# A96 Threapland Junction Improvements Environmental Statement Addendum

January 2009

#### **Environmental Statement Addendum**

**FIGURE 1.2**

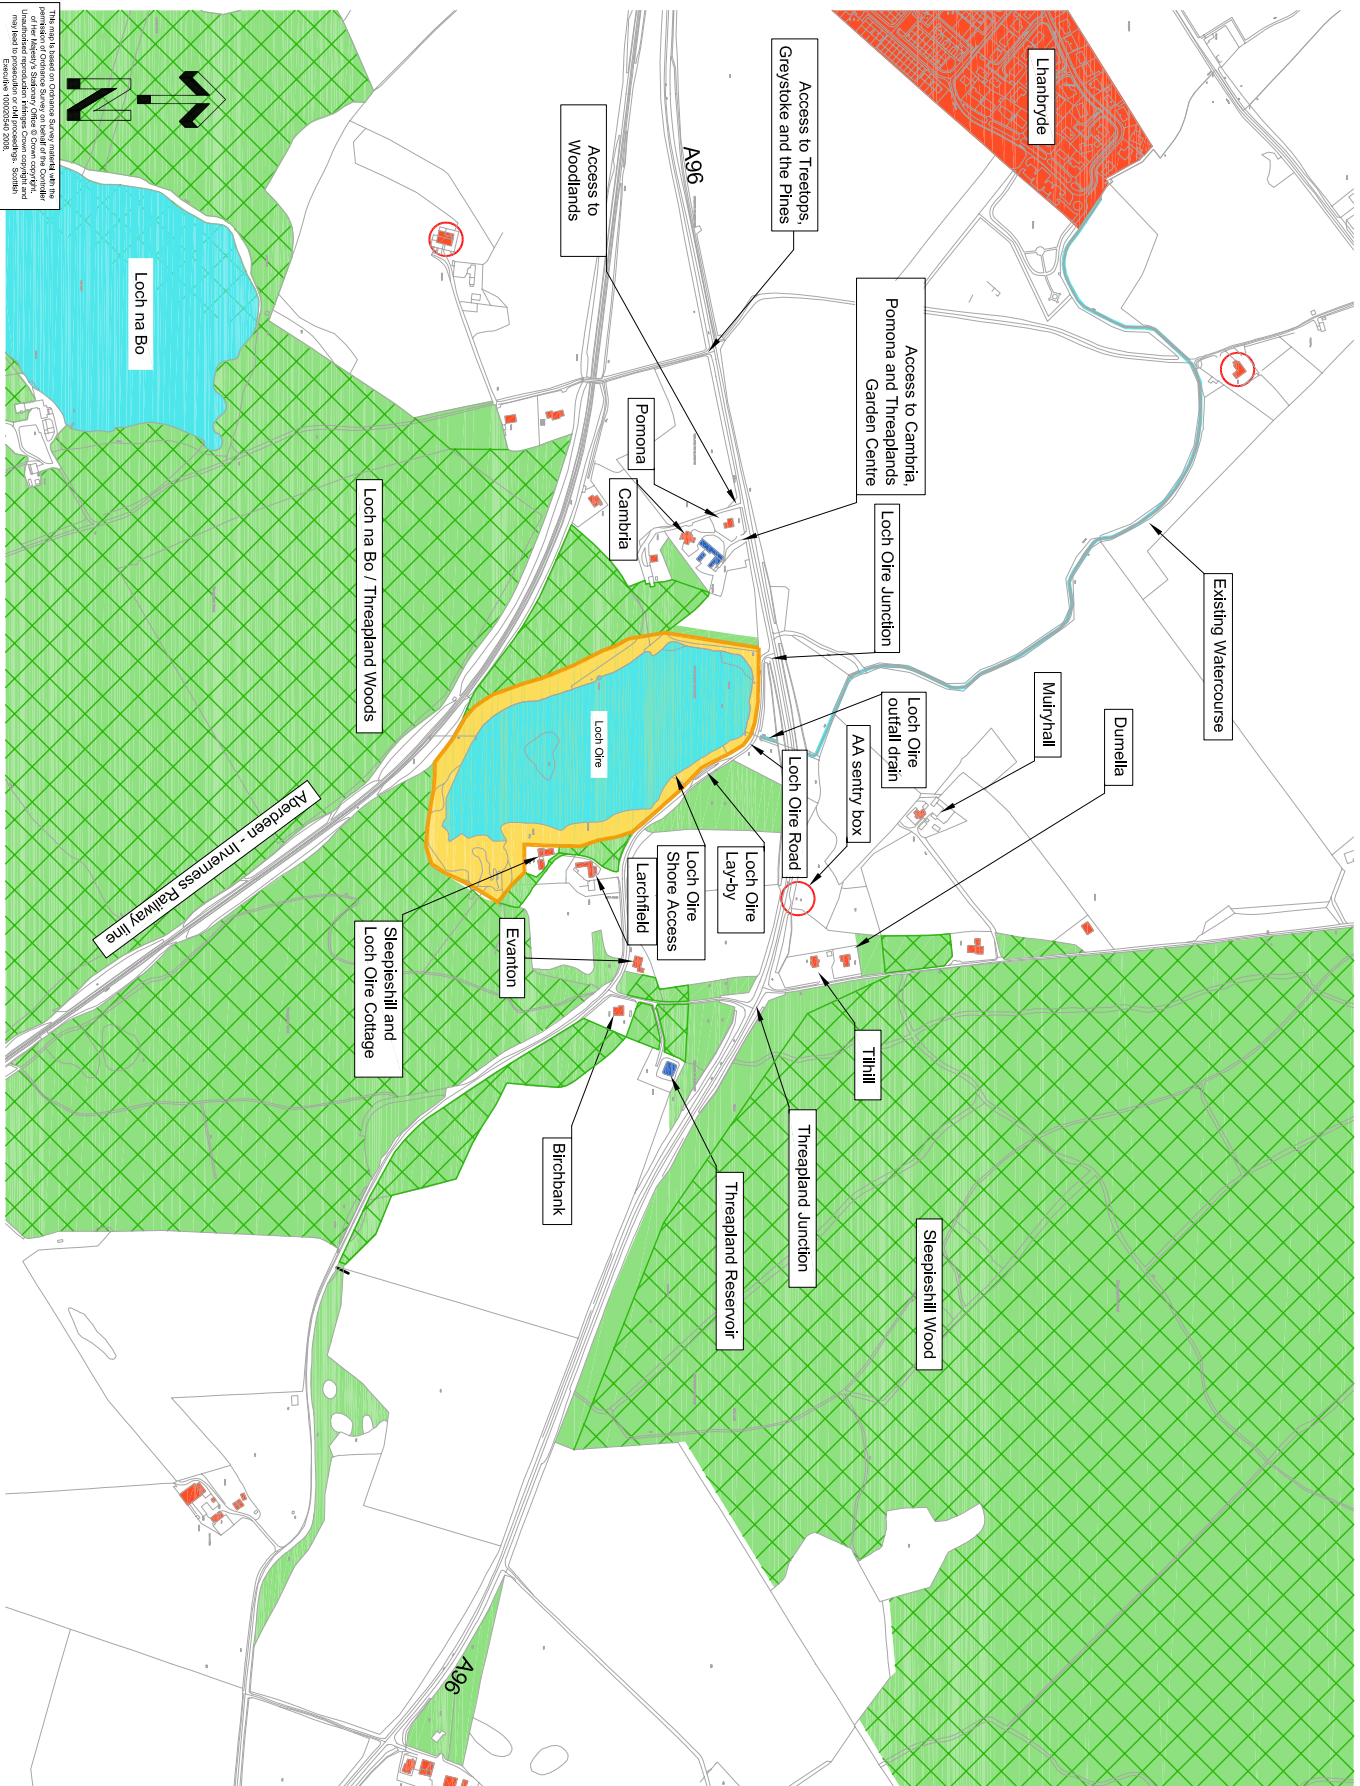
**Chapter 1: Introduction** – Original text is still relevant and is reported in Chapter 1 of the Environmental Statement, October 2008. Figure 1.2 has been revised to show the new location of the Loch Oire Road vehicle turning area and Figure 1.3 has been amended to show the correct SSSI boundary and a more accurate representation of the Ancient Woodland Inventory sites. These amendments are included in Appendix A of this Addendum.

Replace Figures 1.2 (Preferred Scheme) and 1.3 (Baseline Environmental Constraints) with those that follow.

Replace Figure 4.1 (Disruption Due to Construction) with that which follows.

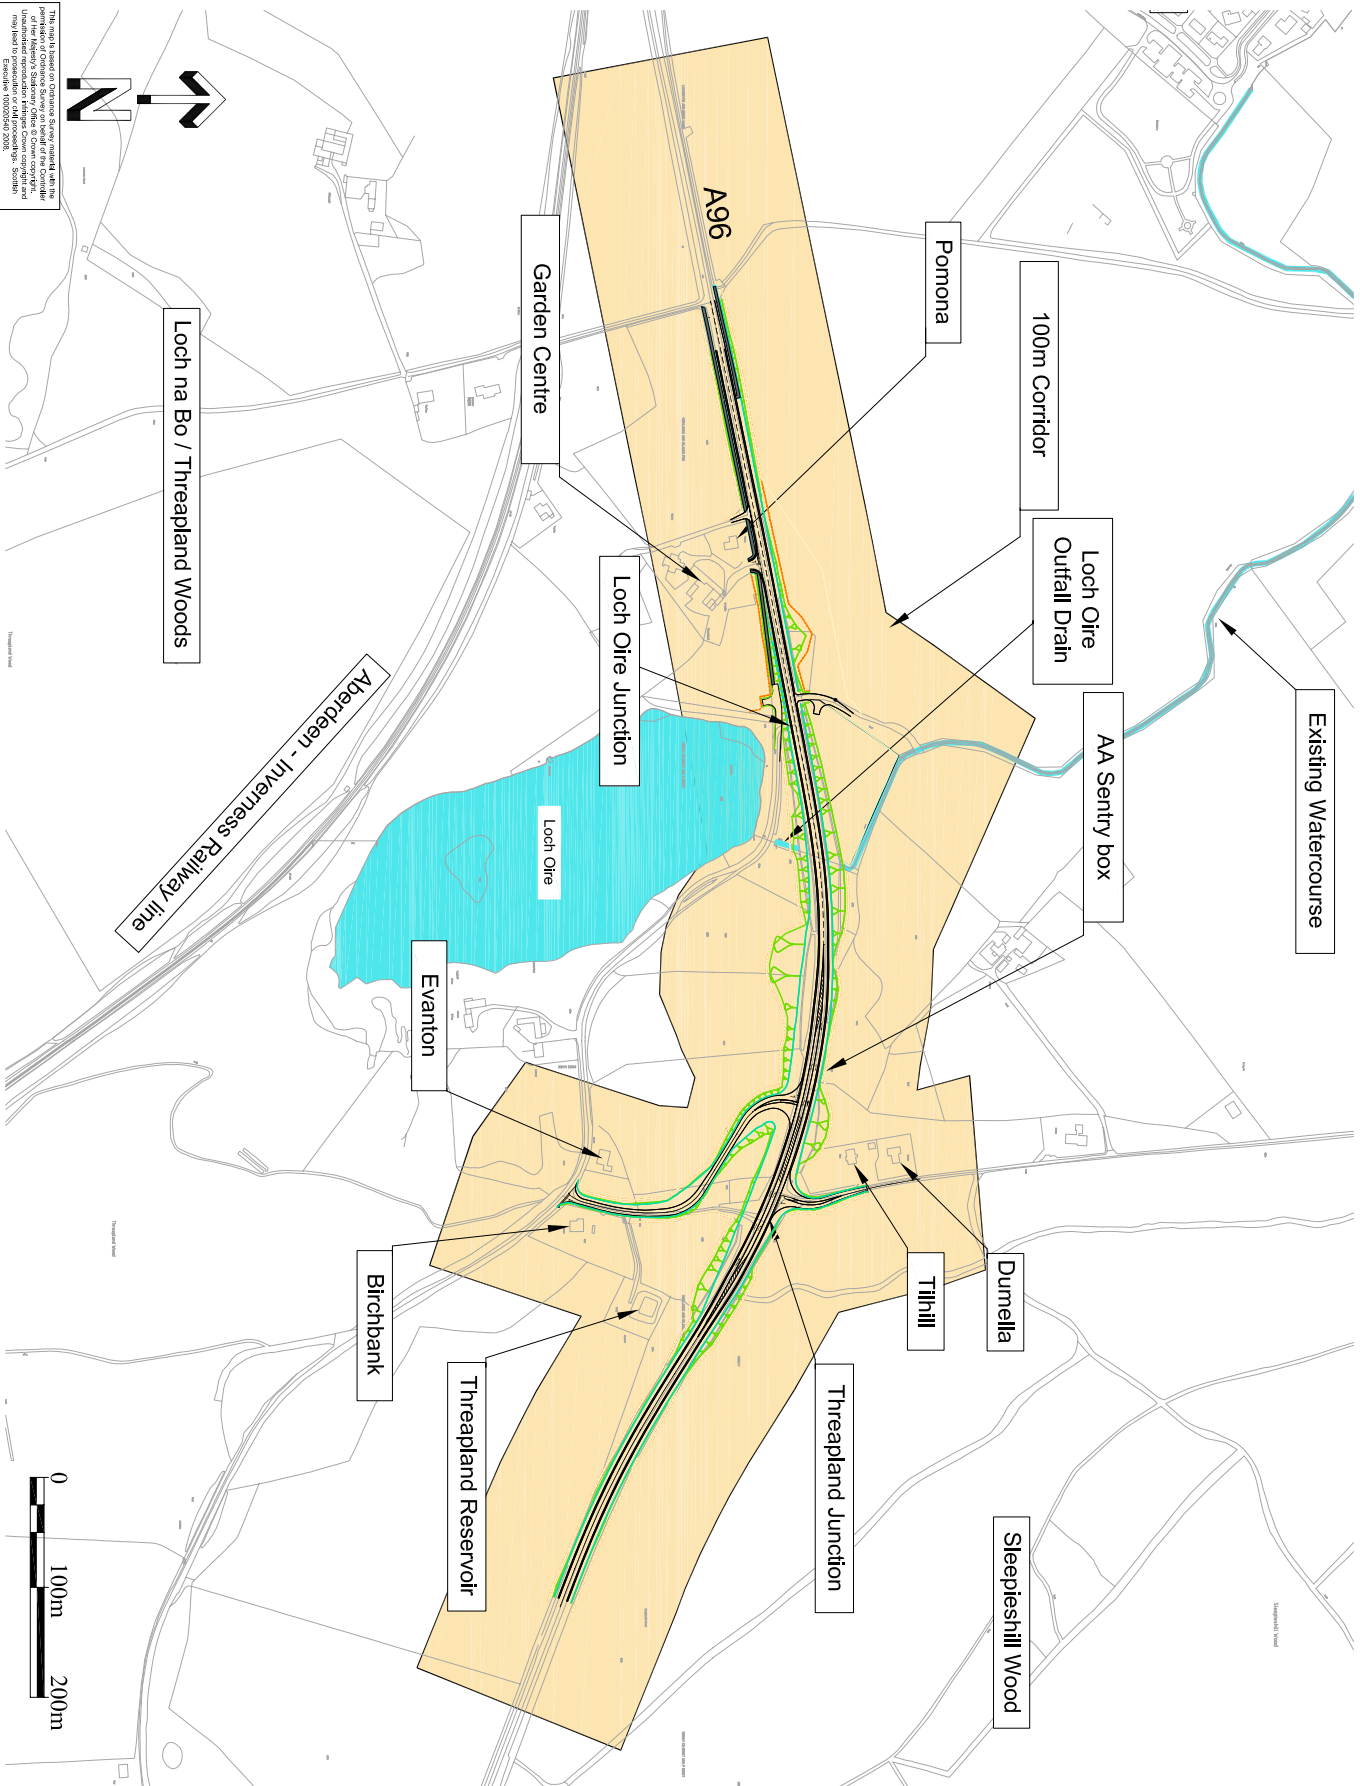
**Chapter 4: Disruption due to Construction** – No additional works are required and therefore there are no substantial changes to this chapter. There have been some minor alterations to the text with respect to the proximity of Loch Oire to the proposed works and also to identify the residential property of Cambria (located within 100m of the Scheme) as a main receptor during the construction period. Figure 4.1 has been updated to show the new position of Loch Oire Road vehicle turning area. These amendments are included in Appendix C of this Addendum.

Replace Figure 5.1 (Statutory and Non-Statutory Designations Sites, Signs of Protected Species, and Invasive Plant Species) with that which follows:

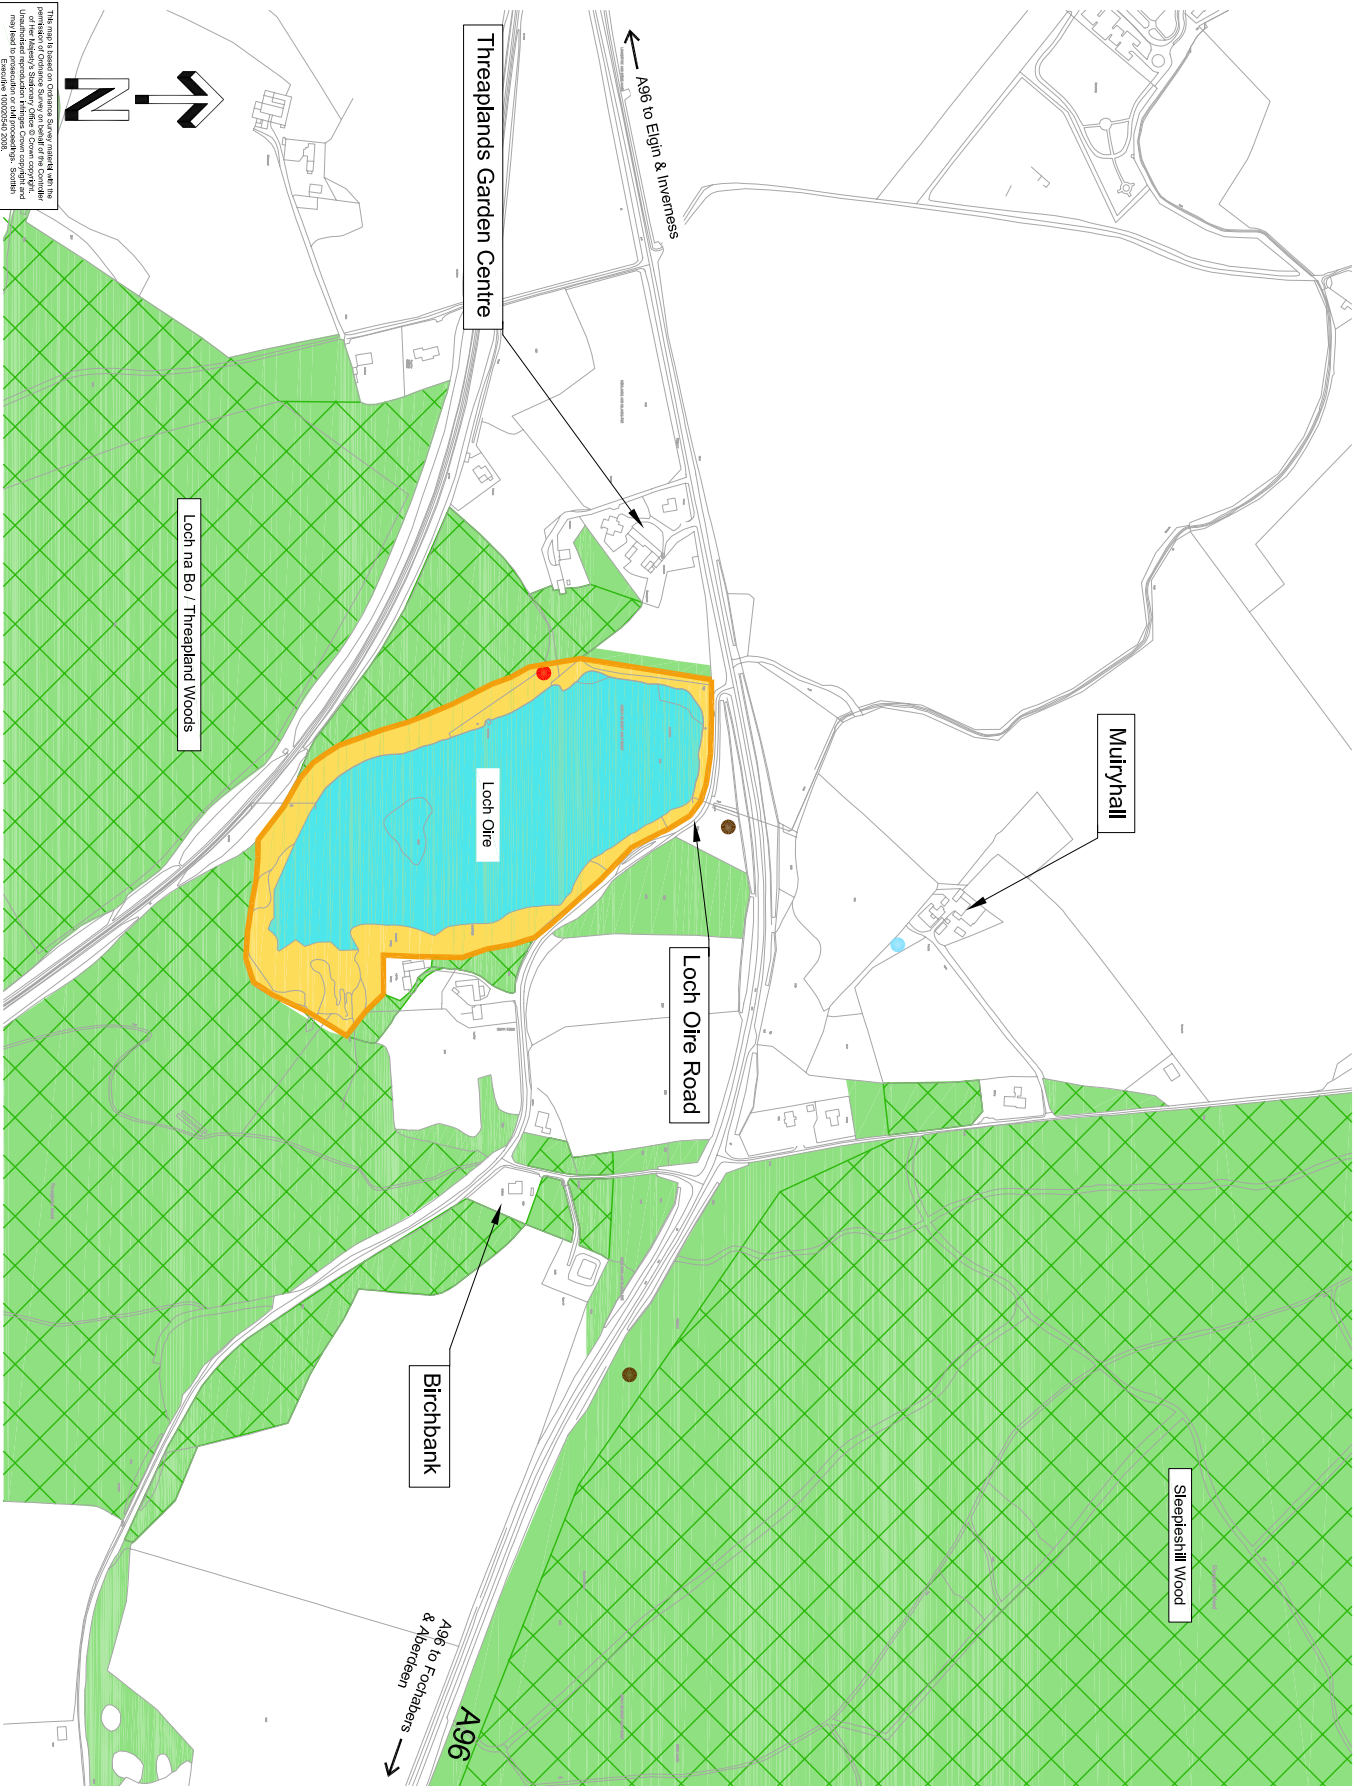
**Chapter 5: Ecology and Nature Conservation** – The amendments to this Chapter relate primarily to the significance of effects on Loch Oire SSSI as a result of changes to the location and layout of Loch Oire Road vehicle turning area. Figure 5.1 has been amended to show the correct SSSI boundary and a more accurate representation of the Ancient Woodland Inventory sites. These amendments are included in Appendix D of this Addendum.
